April 13, 2018

Re: **Data Transmittal**

Clare Central Apartments
1003 and 1033 West Atkinson Avenue
Milwaukee, Wisconsin
Terracon Project No. 58107058A
WDNR BRRTS #02-41-549867
VPLE BRRTS #06-41-560680

SOIL CVOC ISOCONCENTRATION MAP (0-4' BGS)
CLARE CENTRAL APARTMENTS
1003 AND 1033 WEST ATKINSON AVENUE
WISCONSIN

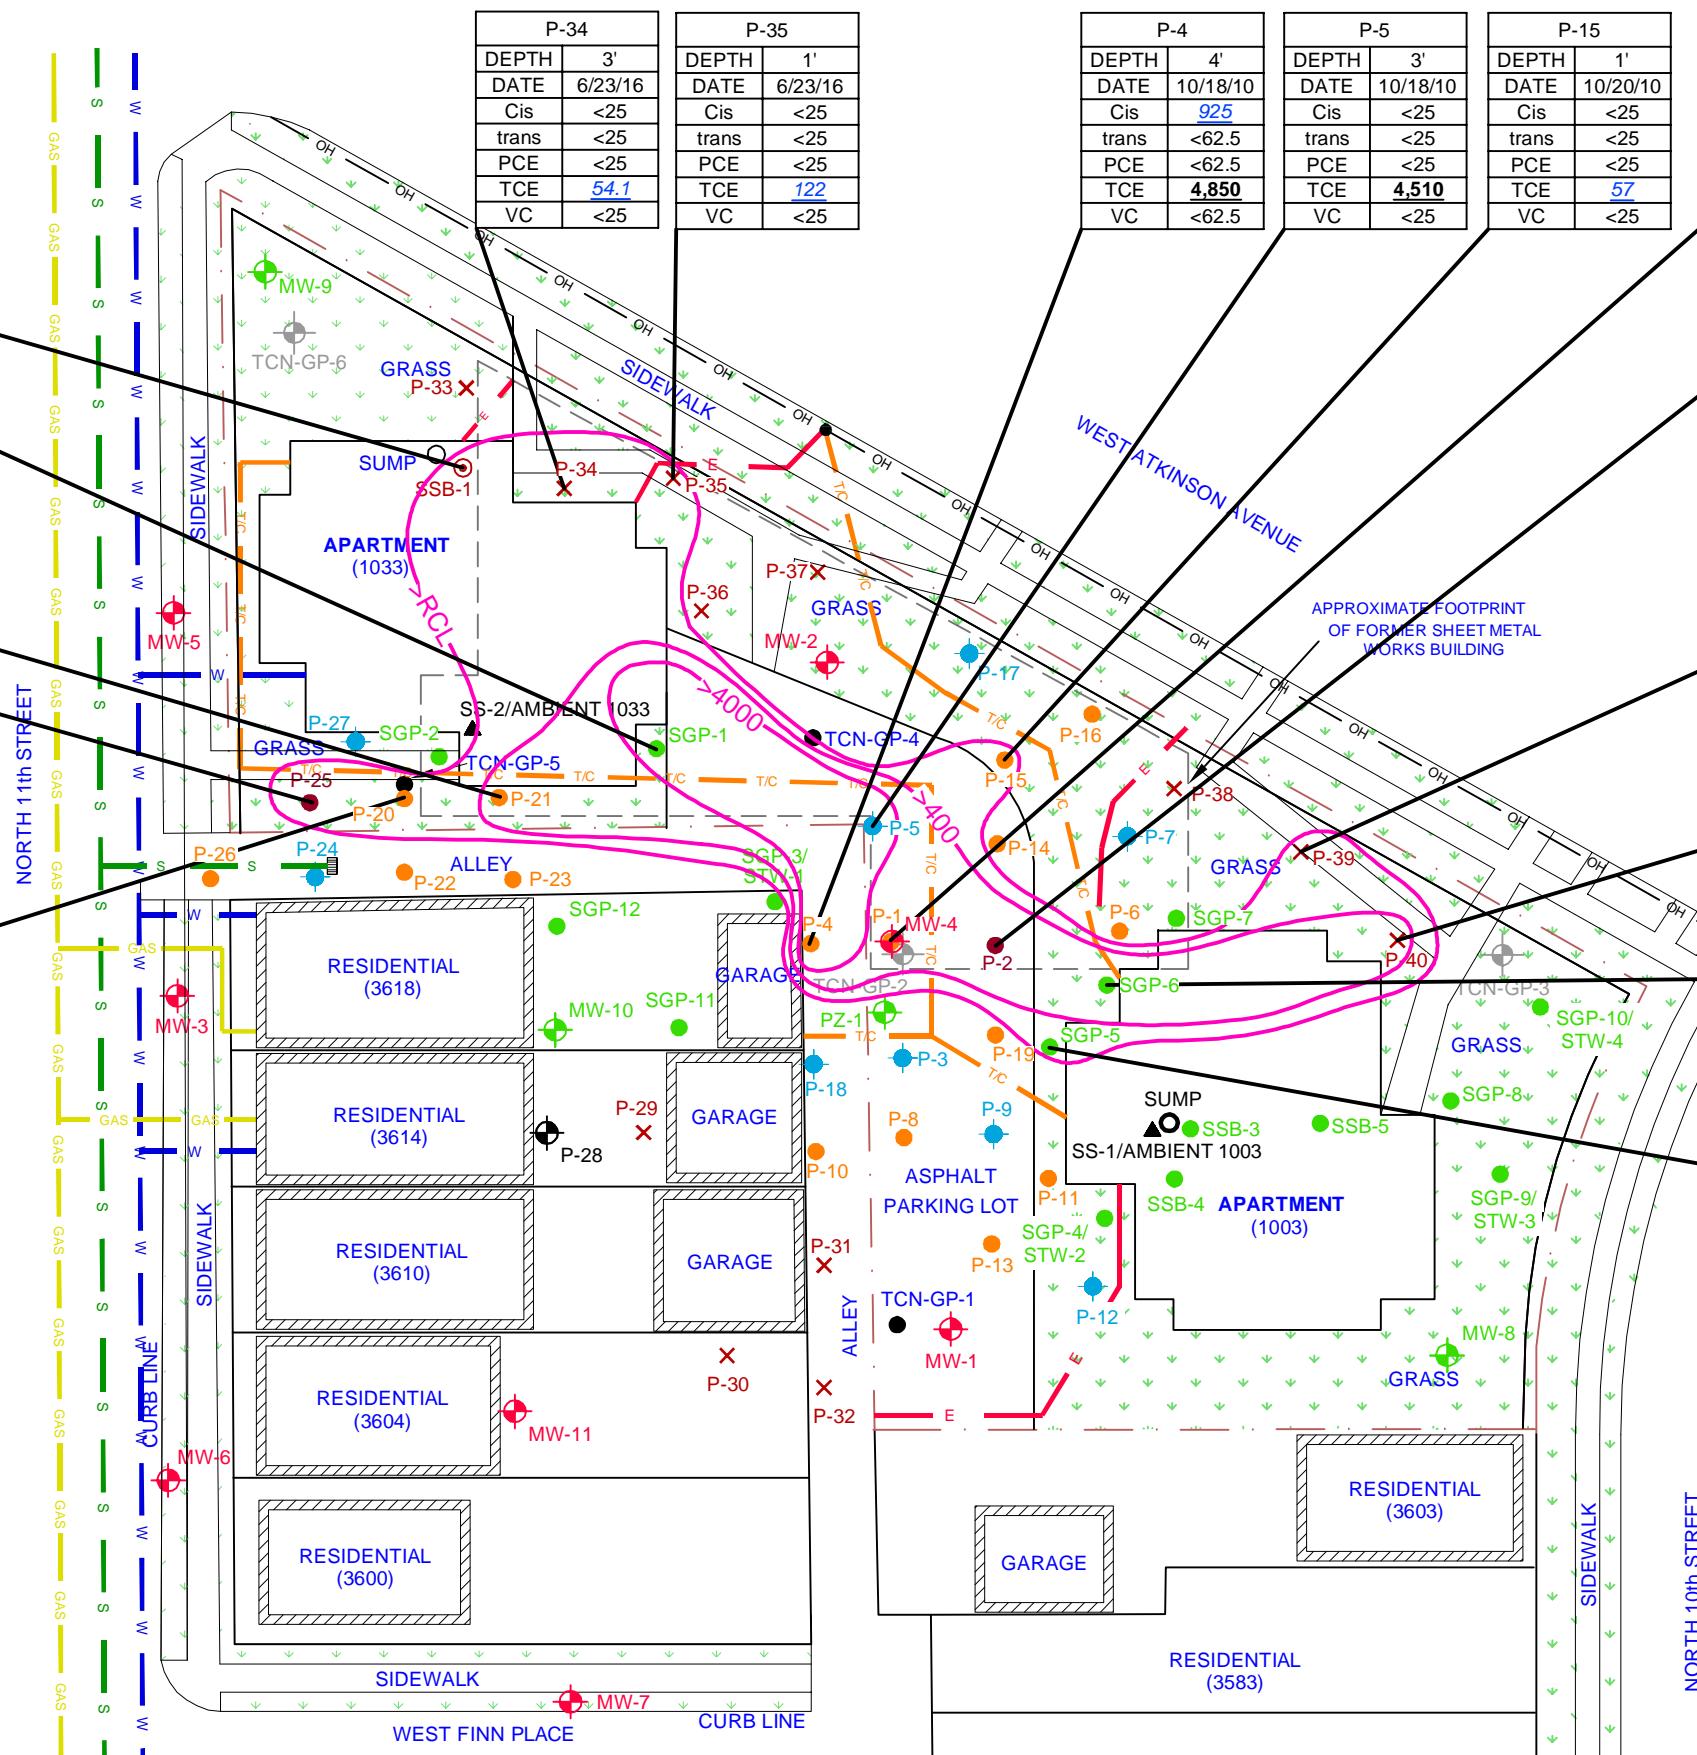
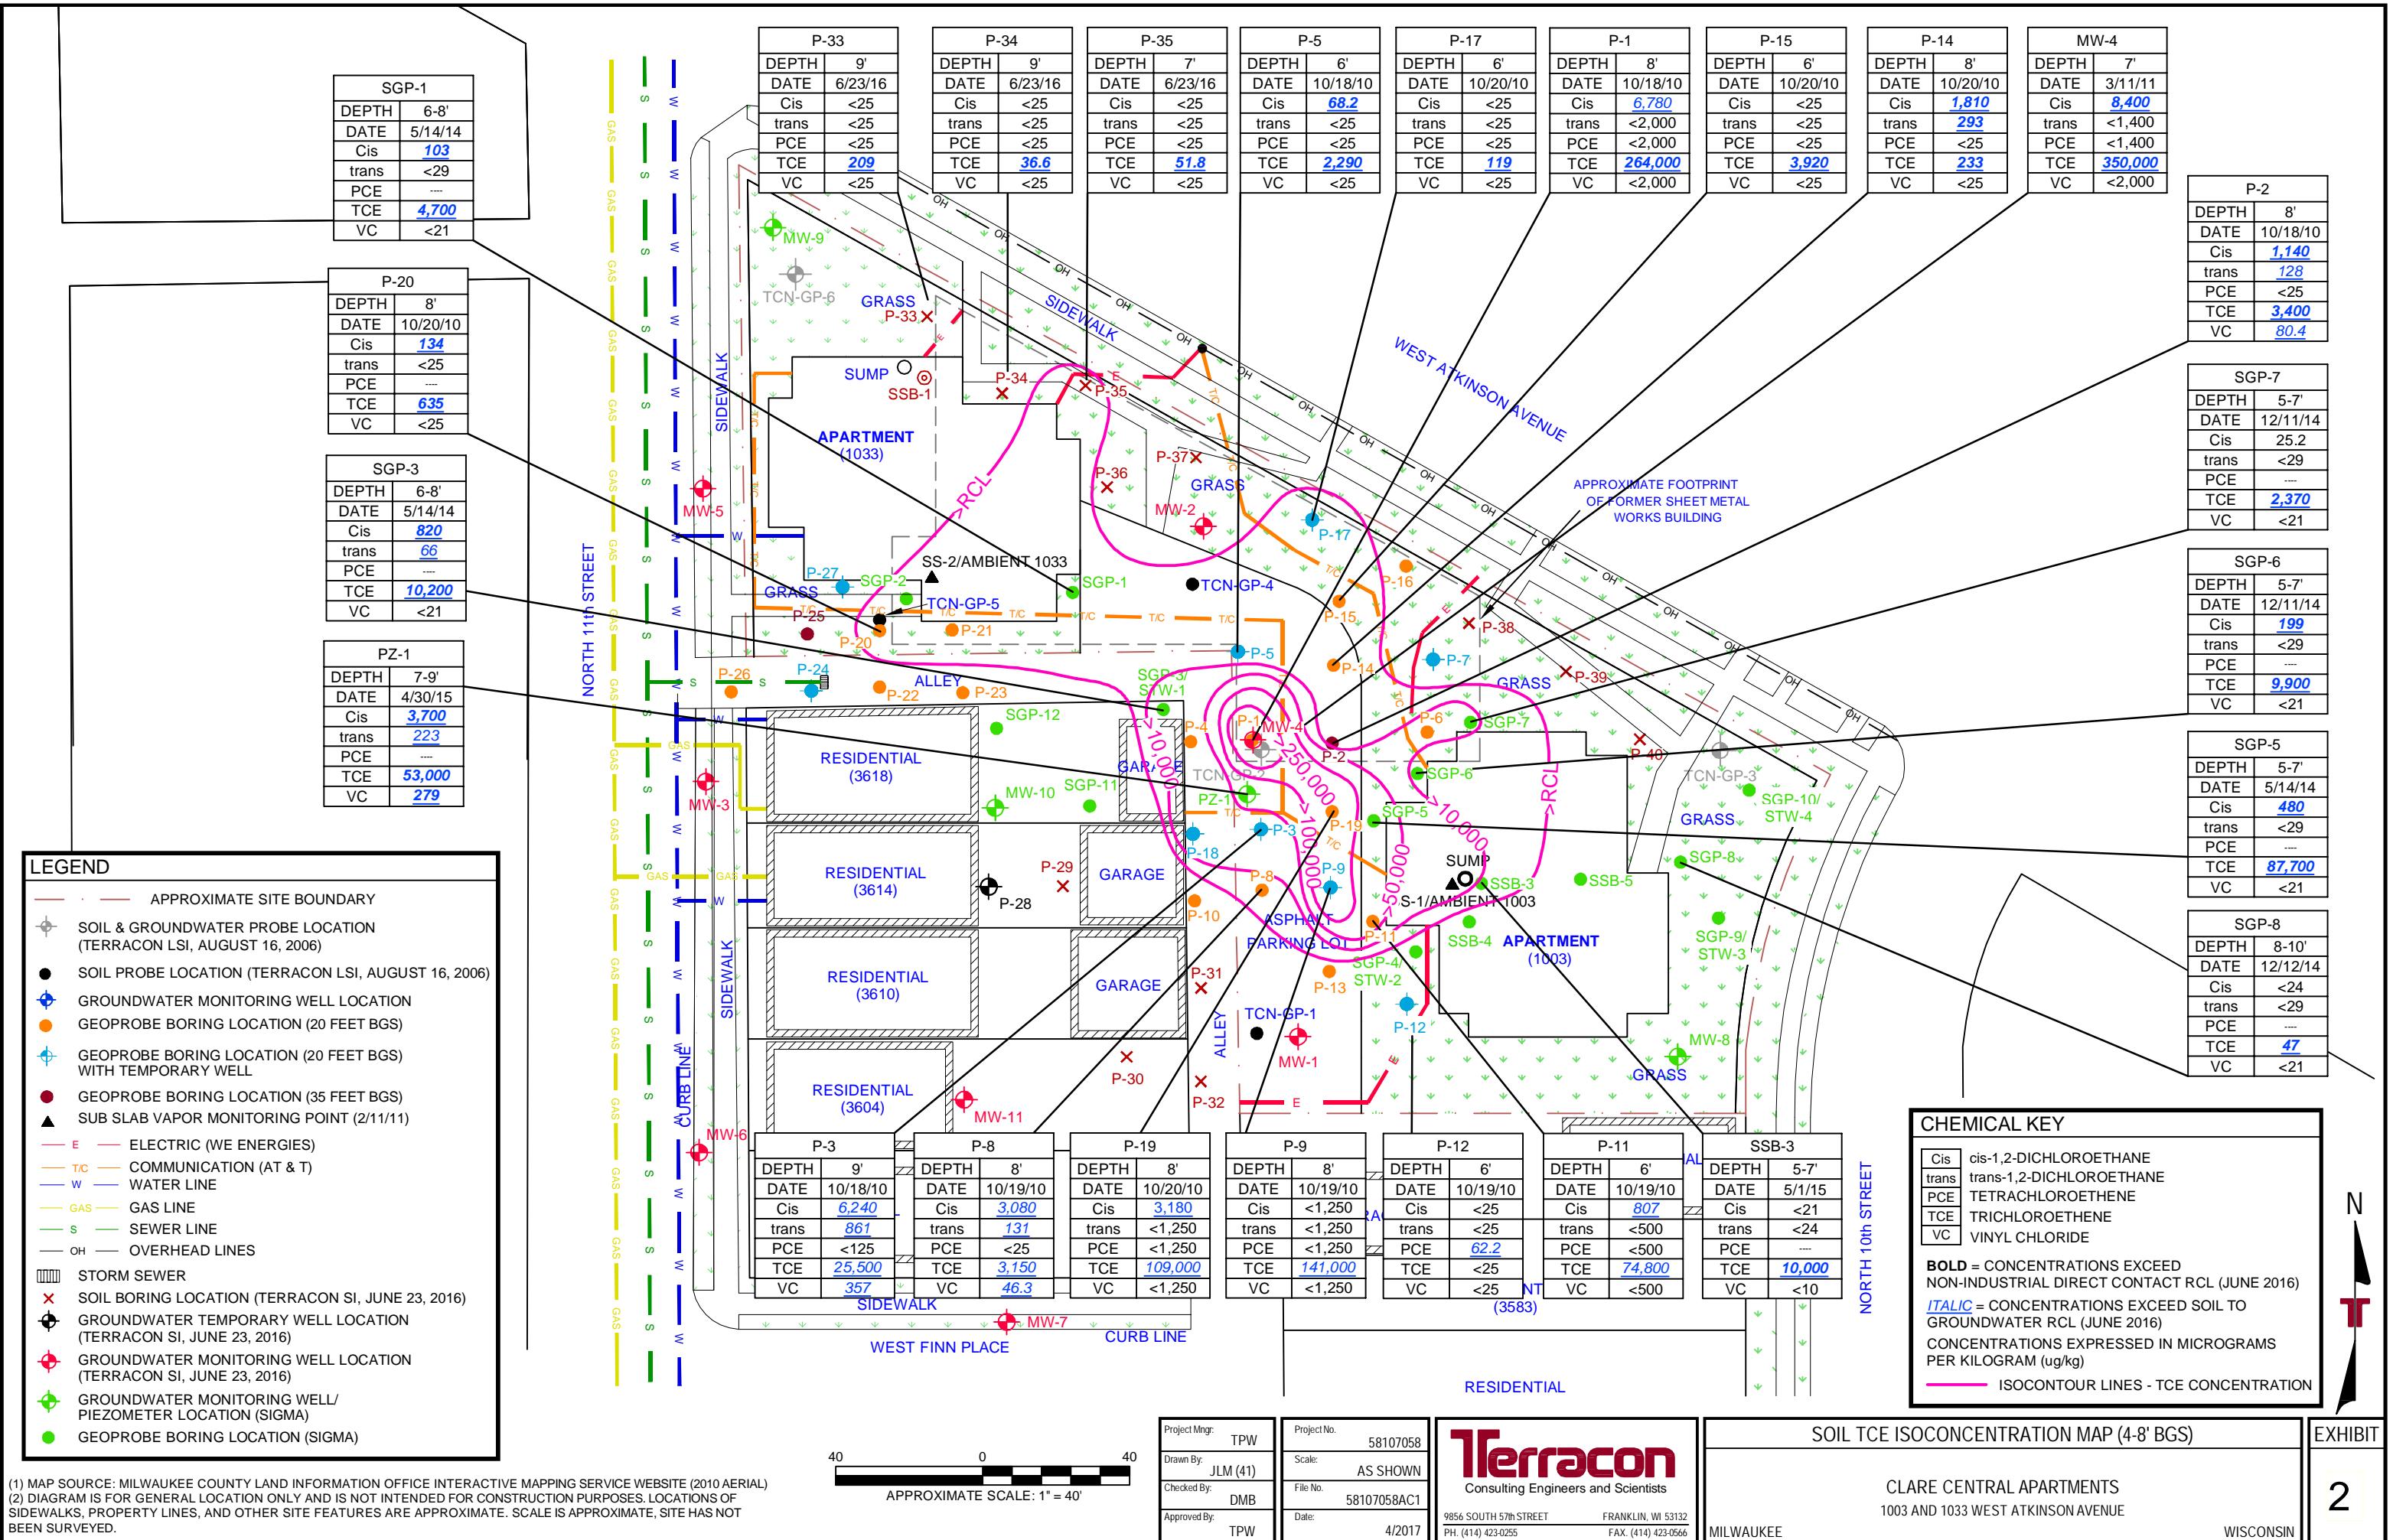
- "It appears that the extent of soil contamination is not defined to the north/northeast beyond soil borings P-33, P-34, P-35, P-39 and P-40. Prepare a brief plan to define the extent of soil impacts in that area".

During the April 2017 meeting, we reviewed the draft soil isoconcentration maps to discuss the further soil delineation to the north/northeast. Borings (P-33, P-34, P-35, P-39, and P-40) are located within 5 to 15 feet from the property line. The property line is adjacent to the concrete sidewalk, which borders West Atkinson Avenue. Trichloroethene (TCE) was detected at concentrations above its soil to groundwater pathway residual contaminant level (RCL) in borings P-33, P-34, P-35, P-39, and P-40; however, the detected concentrations are below its non-industrial, direct-contact RCL. The RCL exceedances are significantly lower than concentrations in soil in the interior of the site. The data indicates a significant source area behind the former wire building in the interior of the site; with

groundwater flow generally to the southwest in this portion of the site, it is unlikely the TCE migrated with groundwater. Rather, Terracon believes the TCE concentrations in soil near the north/northeast property line may have migrated via diffusion from the source area in the soil gas until a stabilized condition was achieved. Given the presence of underground utilities and West Atkinson Avenue, which make further sampling to the north/northeast unsafe, and the decreased concentrations near the property line relative to the source areas, we believe it was appropriate to extrapolate the extent of the soil isoconcentration line to the north/northeast, rather than pursuing off-site sampling. Furthermore, it was discussed that because of other potential sources of chlorinated solvents in the area, off-site soil data may be difficult to interpret as it relates to the site. Specifically, the February 2014 Phase I Environmental Site Assessment (ESA) report identified the following four potential off-site sources of chlorinated solvents:

A Site Plan Map (Figure 2 from the Phase I ESA), CVOC and TCE isoconcentration maps (Exhibits 1 through 3), and tabulated, historical soil analytical results (Table 1) are attached.
